S E R V I C E N O T E

HP 37212B Modem

Firmware Upgrade

Page 2 Service Note 37212B-02C

Table 1: Problem Number vs Firmware Revision

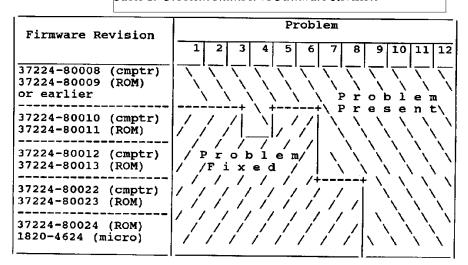
Problems 5, 7, 10 and 12 have easy workarounds and problem 11 is really a no problem. Table 1 shows which problems have been fixed by a firmware update.

With the introduction of ROM chip 37224-80024, the firmware is contained on a single part, the microcomputer with on-board ROM now being replaced by microprocessor 1820-4624.

For a permanent fix to all but problems 10, 11 and 12, replace firmware parts with ROM 37224-80024 in U6 microprocessor chip 1820-4624 in U1. This fix also requires a link from U1(1) to U1(5) and TL1 in the SA position.
